**SHEARON HARRIS NUCLEAR POWER PLANT, UNITS 2 AND 3
DOCKET NOS. 52-022 AND 52-023
RESPONSE TO SUPPLEMENTAL REQUEST FOR ADDITIONAL INFORMATION REGARDING
THE ENVIRONMENTAL REVIEW**

**Shearon Harris Nuclear Power Plant Units 2 and 3
Response to NRC Supplemental Request for Additional Information Regarding the
Environmental Review for the Combined License Application, dated October 30, 2009**

NRC RAI #: 5.4.2-2

PGN RAI ID #: H-0513

Figure 1
Results of Tritium Evaluation

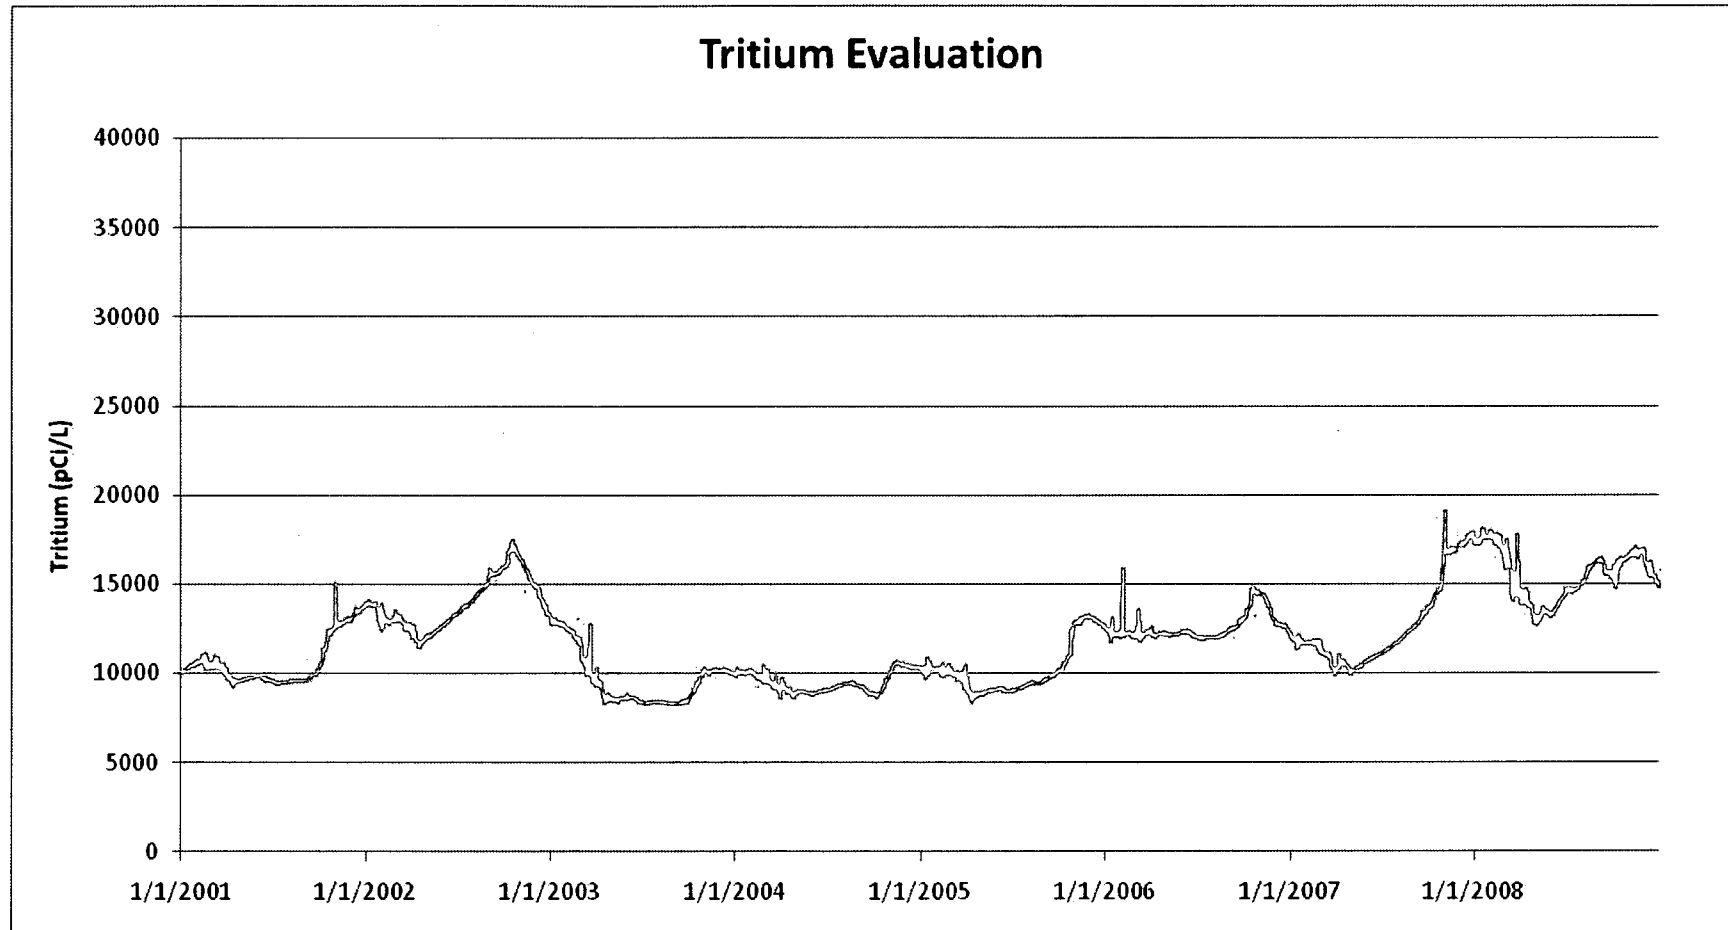
Provide an evaluation of the potential tritium buildup concentration (in pCi/L) in the Harris Reservoir from the addition of liquid effluents containing tritium from the operation of Units 2 and 3.

The predicted tritium levels in the lake segment downstream of the discharge for the proposed reactor scenario are shown on Figure 1. Tritium levels never exceed a level of 20,000 picocuries per liter (pCi/L).
